NBSIR 79-1935

**Proceedings, Federal Workshop
on Excavation Safety,
September 19 and 20, 1978**

Geotechnical Engineering Group
Structures and Materials Division
Center for Building Technology
National Bureau of Standards
Washington, D.C. 20234

Preliminary NBS Report on
Excavation Safety

Figure 1. Minimum Recommended Provisions for Sloped Excavations.

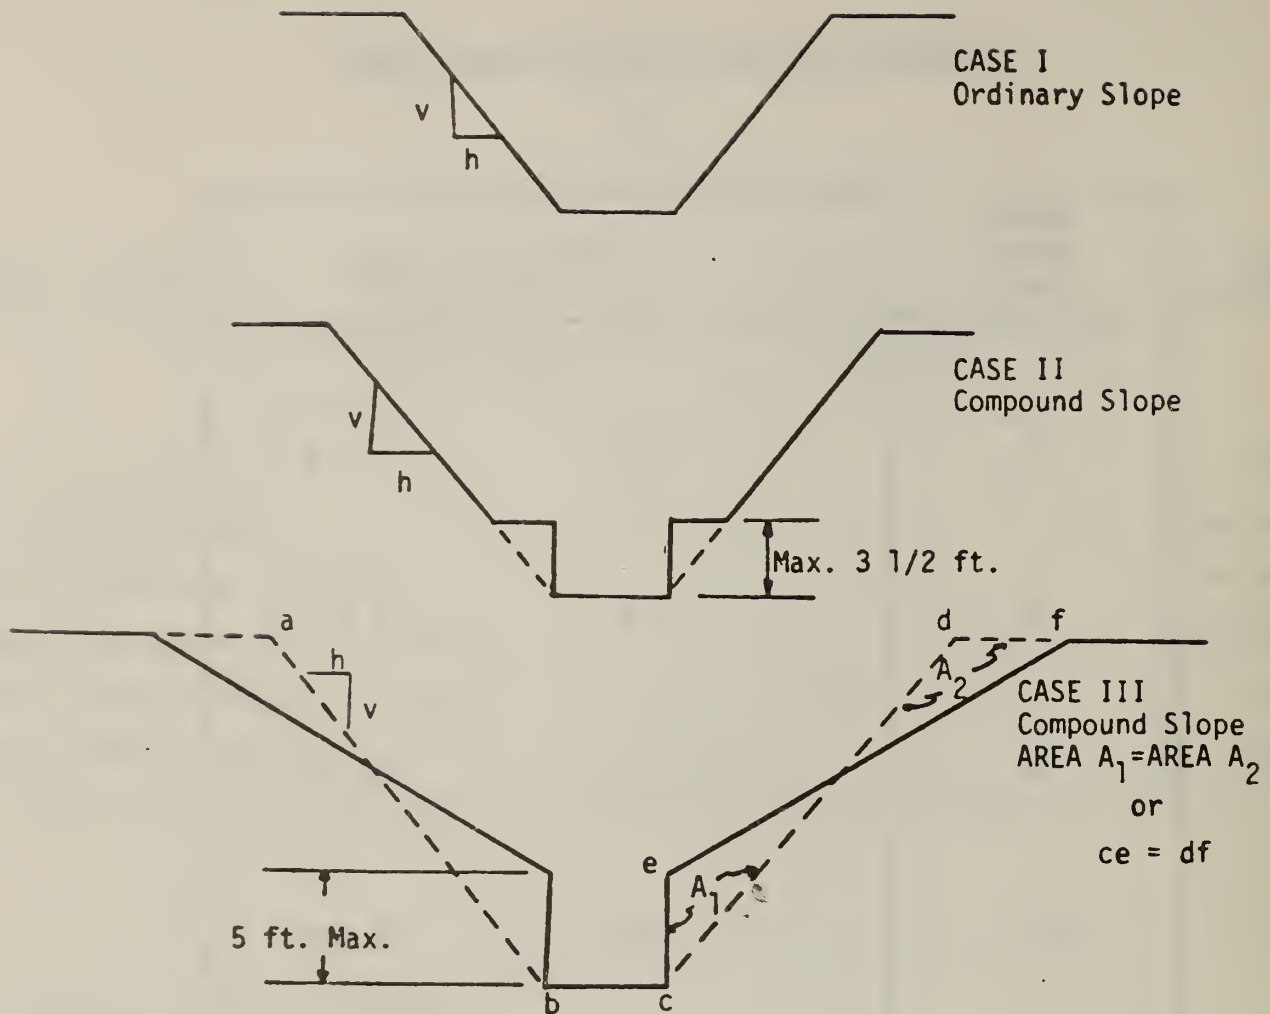
(2) Slopes and Adjustments (Figures 1 and 2). (Pages B-16 and B-17) The compound shape for Case III in Figure 1 of the preliminary NBS report was dropped from further consideration.

A maximum of three foot unshored subditch in a compound trench was recommended.

Shored compound trenches should have the shoring extending sufficiently above the straight sides to prevent roll in of objects or spoil.

7. Do not allow sloped trenches in clay. Require shoring at all times.
8. Do not use the 5' maximum depth on compound slopes. Use 36" or 42" (Page B-16 in Appendix B).
9. In the draft report, Section 1, Table 1 (Minimum Timber Shoring Requirements), change the numbers 4' and 5' in footnote 1(d) to 36" or 42" (Page B-12 in Appendix B).
10. Allow bottom 5 feet of shoring to be removed to permit compaction of lower levels of backfill.
